Well Name: SANDY	Well Location: T27N / R12W / SEC 32 / SWSW / 36.527414 / 108.140029	County or Parish/State: SAN JUAN / NM
Well Number: 1S	Type of Well: OTHER	Allottee or Tribe Name:
Lease Number: NMNM94827	Unit or CA Name:	Unit or CA Number:
US Well Number: 3004532348	Well Status: Temporarily Abandoned	Operator: DJR OPERATING LLC

Notice of Intent

**Plug and Abandonment Procedure
for
DJR Operating, LLC
Sandy 1S
API # 30-045-32348
SW/SW, Unit M, Sec. 32, T27N, R12W
San Juan County, NM**

DJR Operating, LLC Proposed Wellbore Diagram

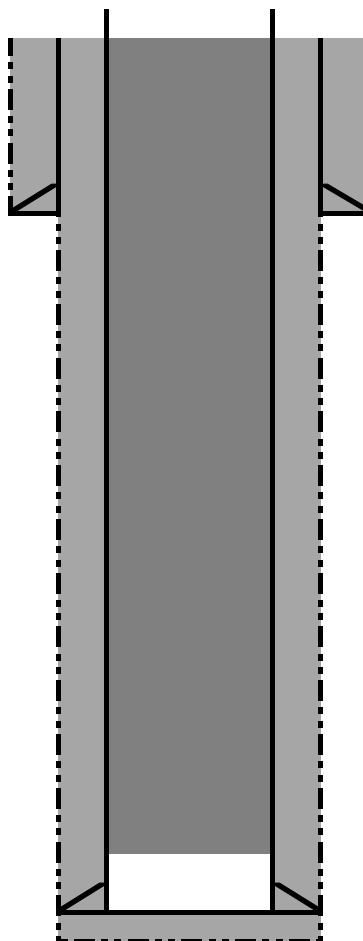
A Geologic Report wasn't completed for this particular well due to well logs for the well & nearby wells are inadequate to determine formation tops. The tops were going to be adjusted to the BLM/NMOCDs formation tops. In the BLM approved sundry, BLM Geologist, Chris Wenman noted the P&A Procedure should be adjusted to cement from PBTD at 1380' to surface which NMOCD Geologist Kate Pickford agreed to this solution. Due to technical issues within the BLM system, when generating the approved sundry, the AFMSS2 did not capture Mr. Wenman's notes. DJR has made the modification of cement from PBTD to 1308'.

Plug 1: Mix and pump sufficient Class G cement to bring cement from 50' below top of Fruitland to surface.
